PROJECT
**COUNTY OF ROCKLAND
CAPITAL PROJECT NO. 1307
HIGHWAY DEPARTMENT /
EMERGENCY OPERATIONS FACILITY**
COUNTY OF ROCKLAND, NEW YORK

**ELECTRICAL BUILDING 05
POWER PLAN**

No.	DATE	REVISION	BY
1	11/27/19	ADDENDUM 07	VB

ISSUED FOR **BID SET**
DRAWING NO. **5.06.131**
OF SHTS

ELECTRICAL BUILDING 05 POWER PLAN

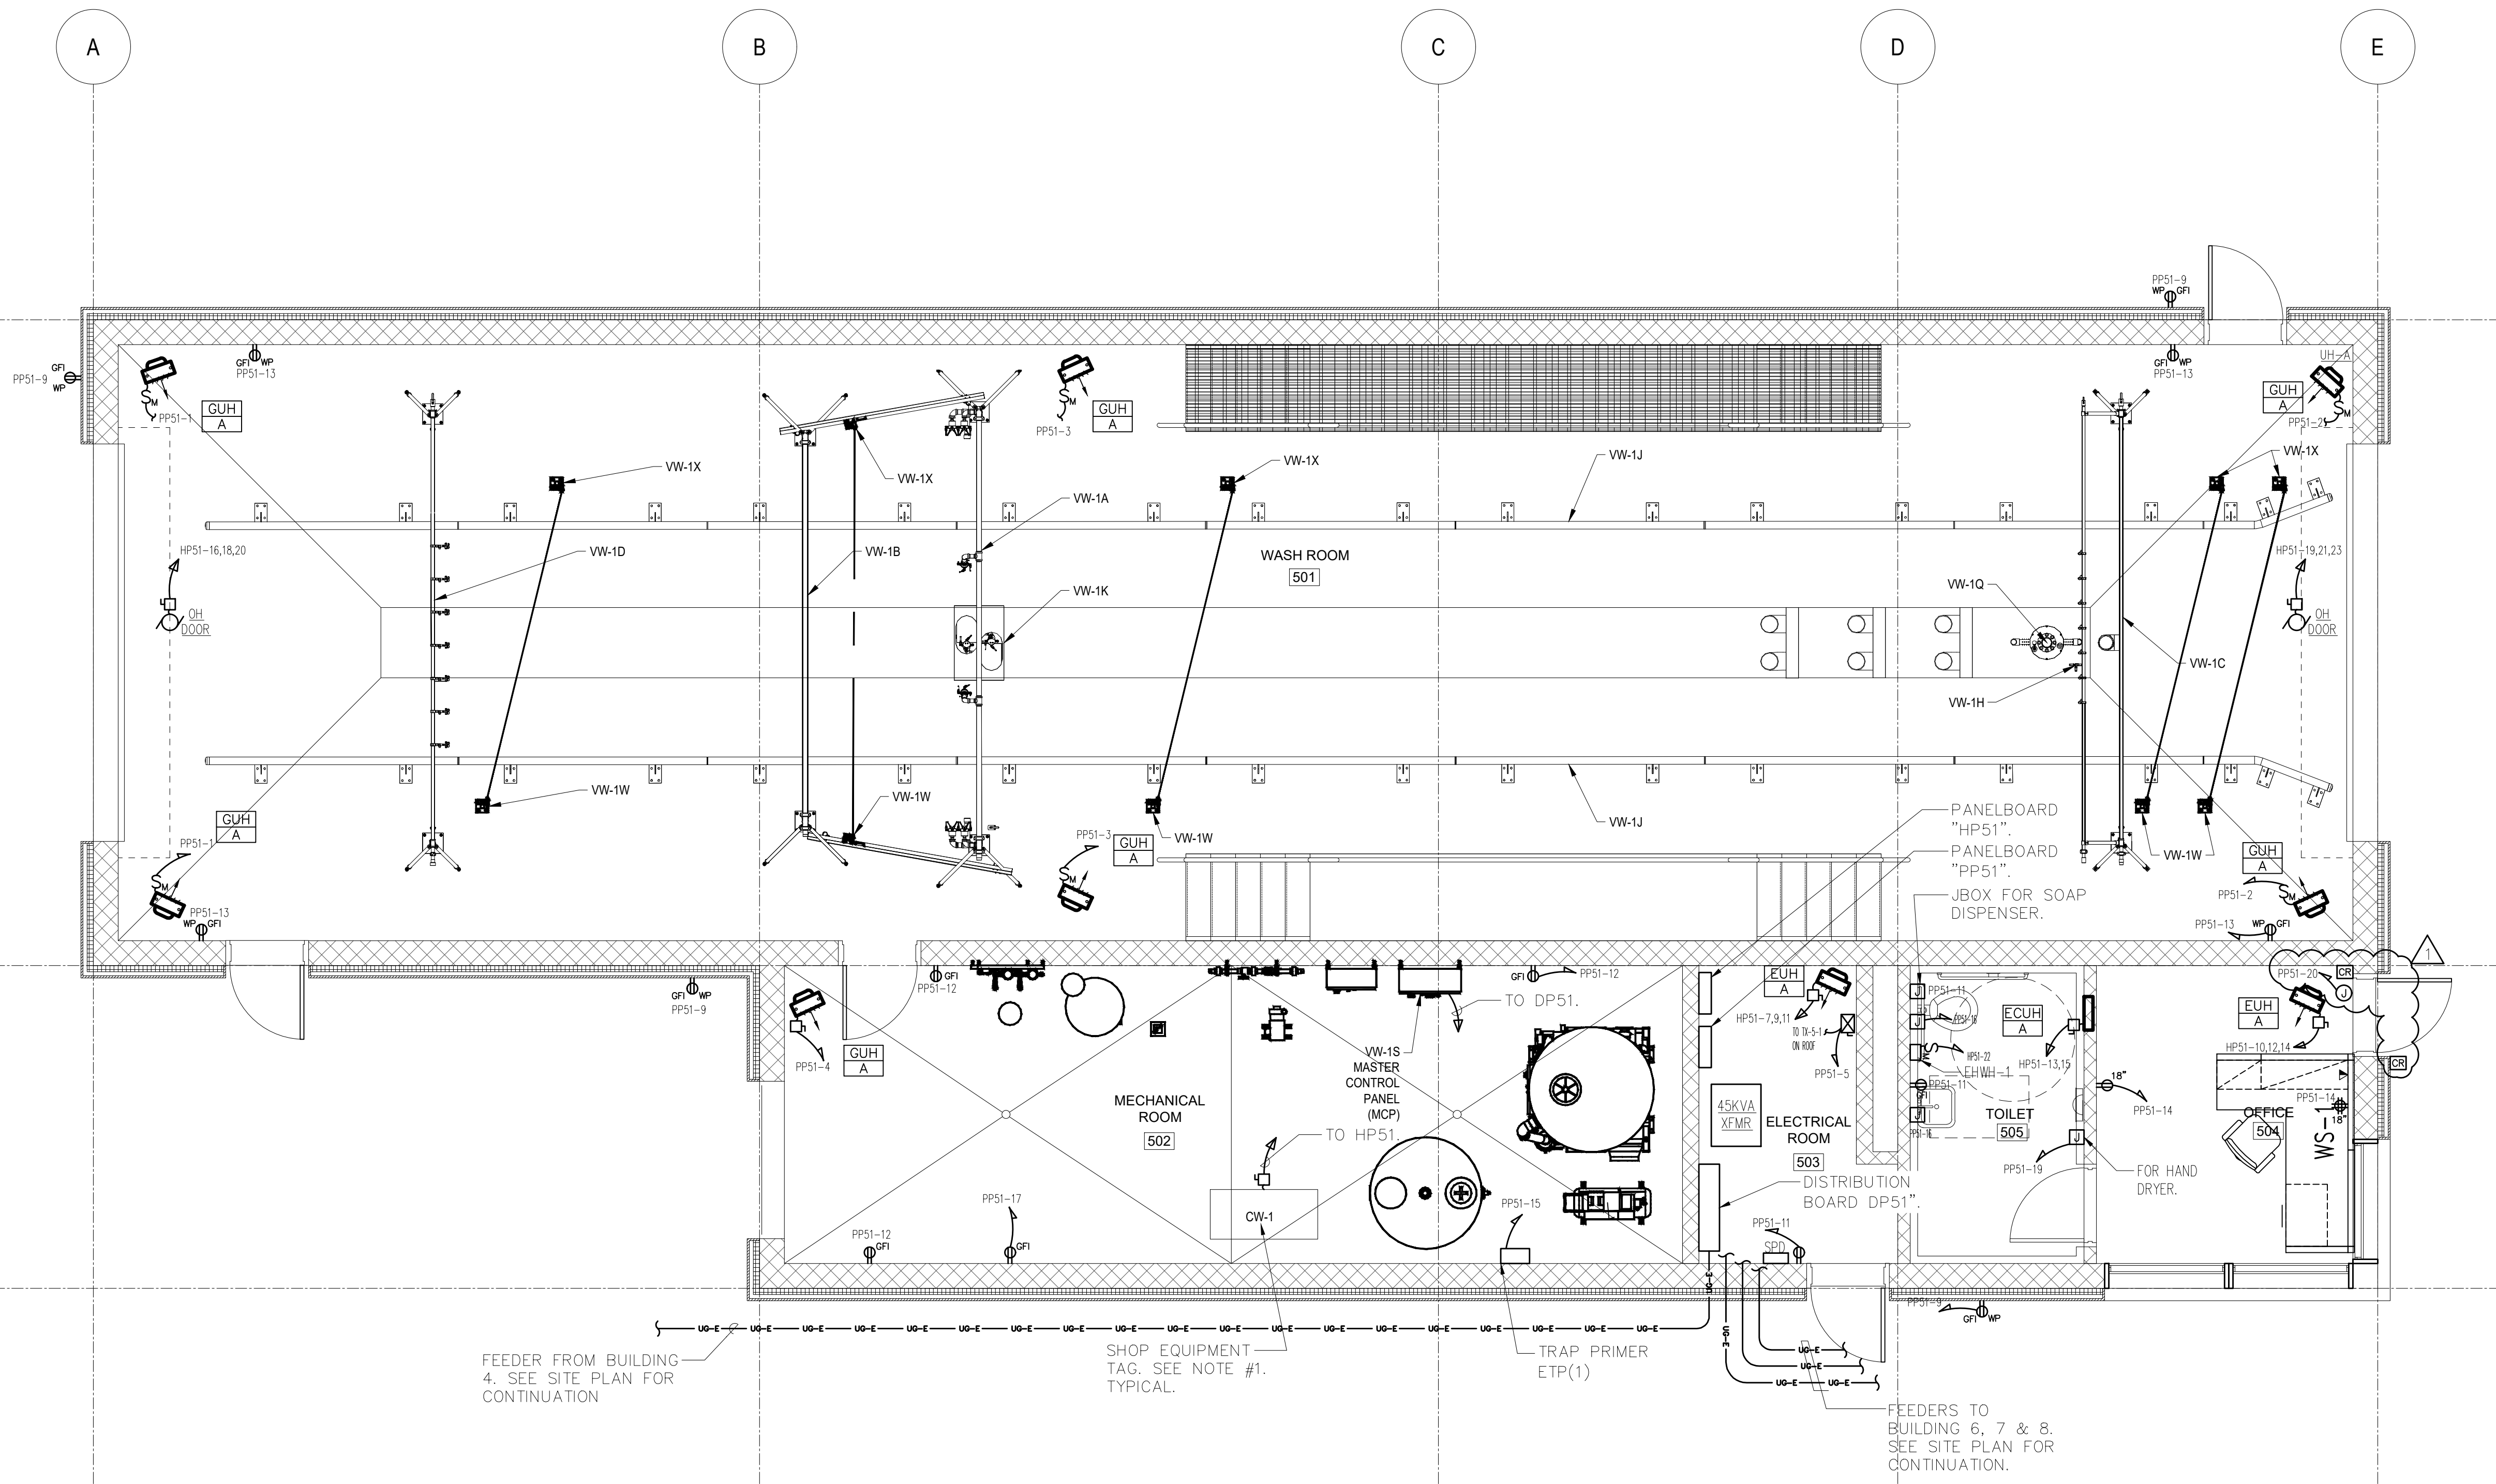
ADD ALTERNATE #1
ALL WORK ASSOCIATED WITH BUILDING 5 SHALL BE PRICED AS PART OF ADD ALTERNATE #1.
